## Service Bulletin

REFRIGERATOR-FREEZER REF 05-00 SXS-24, 28 & 30 CU. FT. MODELS FOOD FREEZING ON TOP FRESH FOOD SHELF

**MAY 2000**

Figure 1

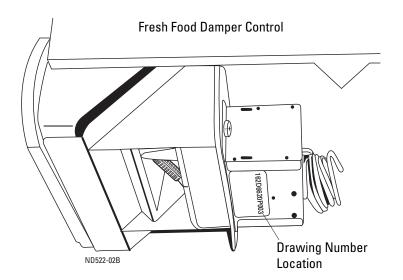
- Remove the Temperature Control/Light Shield to expose the fresh food damper control.
- 2. The fresh food damper control installed in the refrigerator should have the identifying drawing number **162D6620P003** (Figure 1). If the damper control is identified by any other number, remove that damper control and replace with damper control **WR9X10002**.
